Robert L. Mittl General Manager
Nuclear Assurance and Regulation

HOPE CREEK GENERATING STATION
DOCKET NO. 50-354
DRAFT SAFETY EVALUATION REPORT
OPEN ITEM STATUS

Public Service Electric and Gas Company hereby submits the enclosed responses to DSER open items and FSAR Questions, and revised FSAR Section 6.2.5.2.1 for the Hope Creek Generating Station.

FIGURE 1 - TEST SETUP FOR TRAY-TO-TRAY SEPARATION

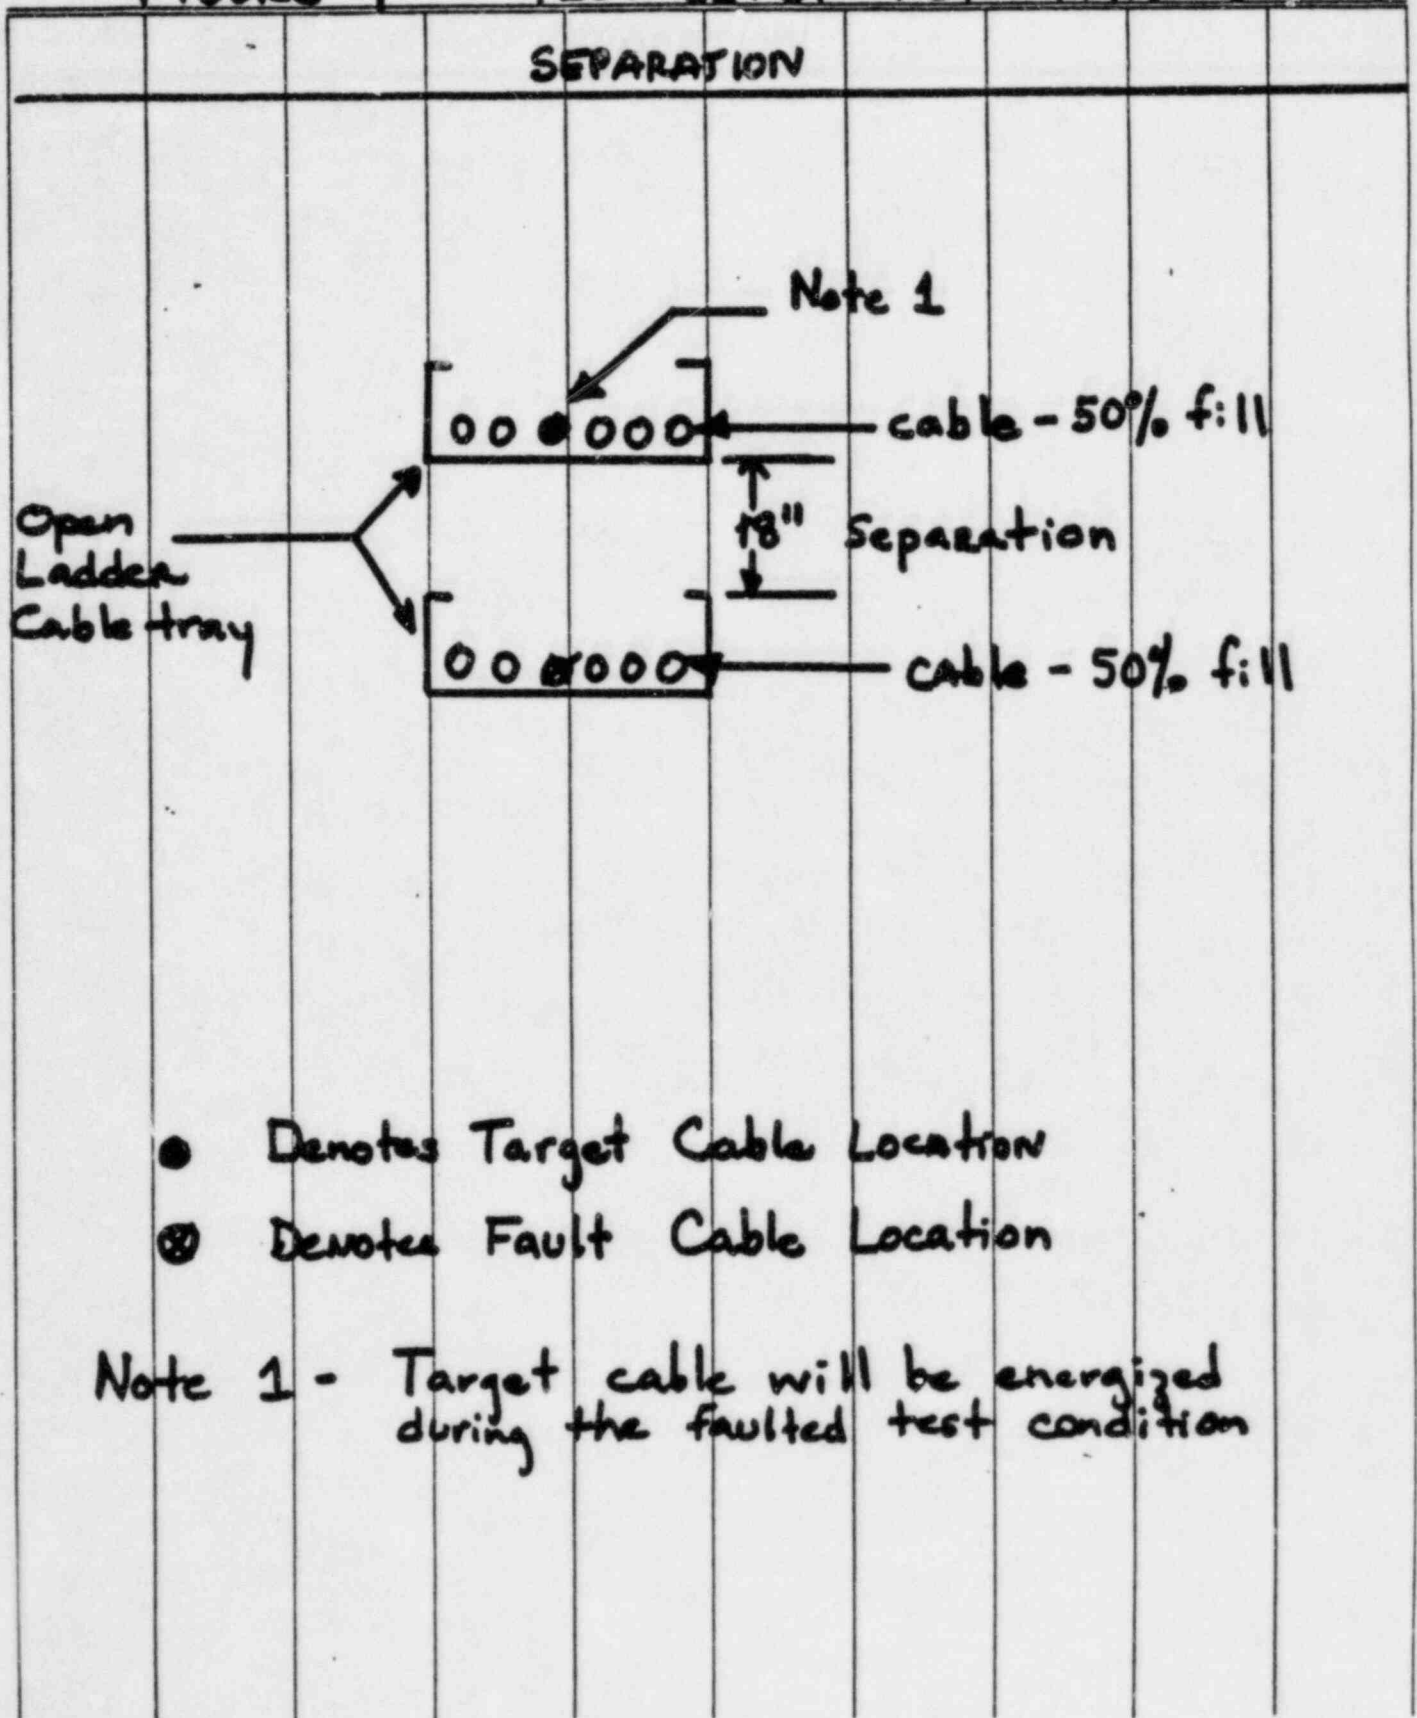
In Sections 1.8.1.75 and 8.1.4.14.3.1 of the FSAR you state that separation between redundant cable trays in the cable spreading area, control equipment room, relay room, and main control room are separated by 18 inches of separation required by IEEE Standard 384-1974. Provide analysis substantiated by test that demonstrates the adequacy of 18 inches of separation.

These tests shall consist of a series of tests with two vertically separated horizontal cable trays (see Figure 1). The test setup shall be identical for each test with the exception of the location of the faulted cable.

The test specimens shall be placed in the cable tray assembly as shown in Figure 1. This apparatus shall be assembled to the indicated dimensions. The following guidelines shall be observed with regard to the materials and construction of the cable tray assembly:

3. The upper and lower cable trays shall be filled to a 50% fill level (by area) using an assortment of six ft unpowered control and instrumentation cables from PSE&G stock.
4. One energized 2/C Size 16 AWG cable and one energized 3/C Size 14 AWG cable shall be placed inside the cable trays that do not have the faulted cable. The energized "target" cables shall be located in the worst case locations (directly above, underneath or next to the faulted cable) as shown in Figure 1. (NOTE: Figure 1 shows the fault and "target" cable locations for the two tests).

FIGURE 8.3-14 Amendment

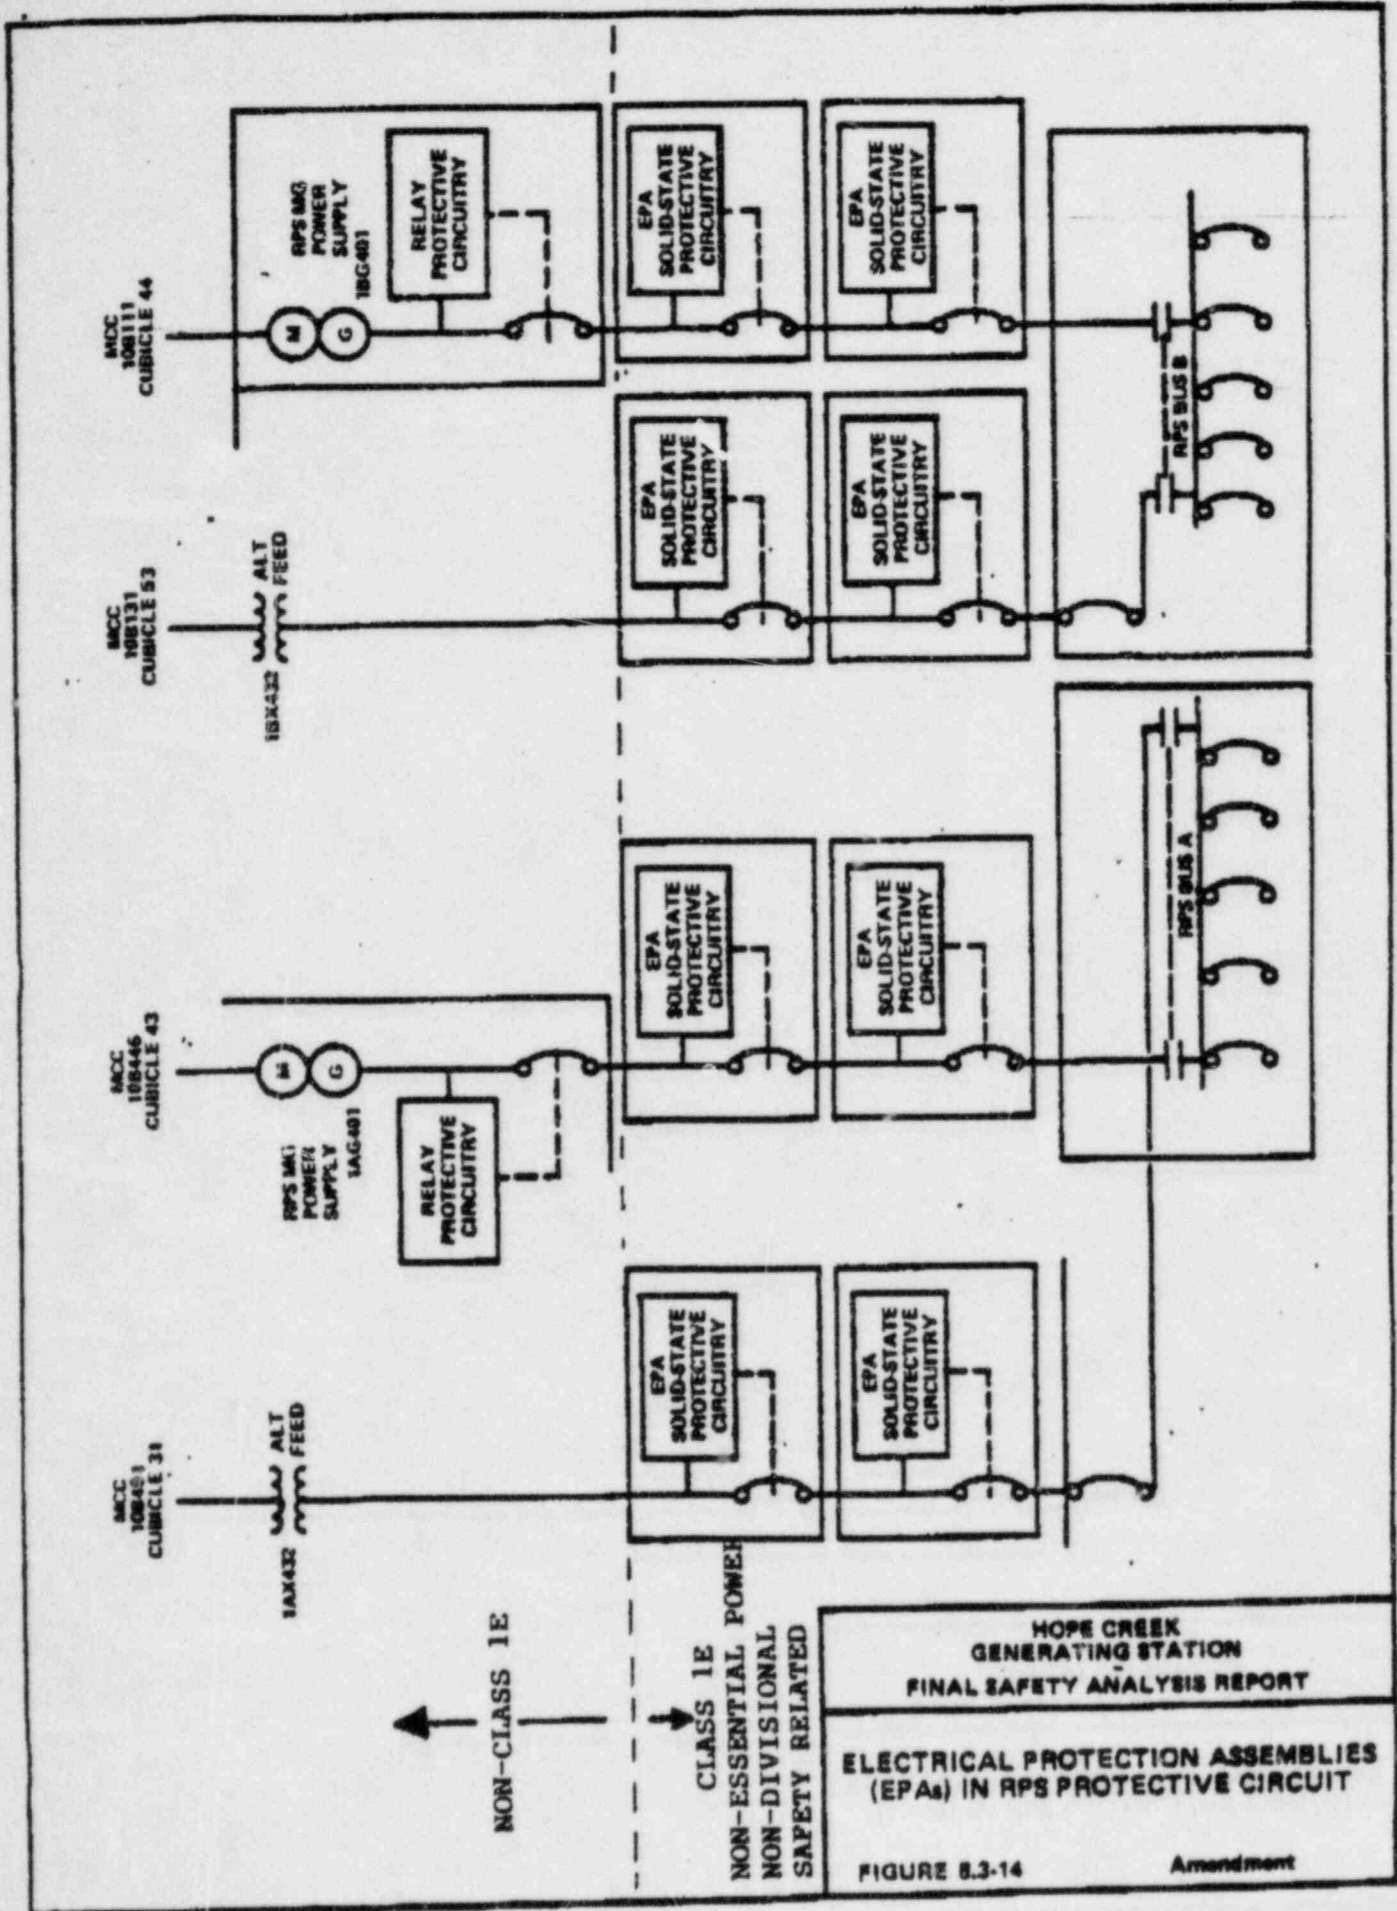
The staff believes that the physical separation provided in the design of the RPS cabinets may not satisfy the requirements of Regulatory Guid 1.75 or the plant separation criteria and is, therefore, unacceptable. As an example, it has been noted on similar plants that the cabinet lighting and power circuits (which are not treated as associated circuits) becomes associated with Class 1E circuits inside the RPS cabinets. Section 8.1.4.14 includes a brief discussion on the physical separation provided within panels, instrument racks and control boards for the instrumentation and control circuits of different divisions. Review the design of all Class 1E cabinets for separation between non-Class 1E and Class 1E circuits. Provide the staff with a listing of the cabinets which were reviewed and describe in detail how physical separation is maintained within the panels, racks and boards for those cases where a 6 inch air space cannot be maintained. Provide a summary of the analysis and testing performed to support this lesser separation. Include in the discussion the separation provided for associated circuits, internal wiring identification and the use of common terminations.

The NMS is supplied with 120-Vac, 60-Hz power from UPS busses 1 & 2. A design change has been authorized for the installation on each bus of redundant electrical protection assemblies (EPAs), which will monitor the incoming voltage and frequency.

The PRMS is supplied with 120-Vac, 60-Hz power from RPS busses A and B. EPAs are already installed on each bus to provide voltage and frequency protection.
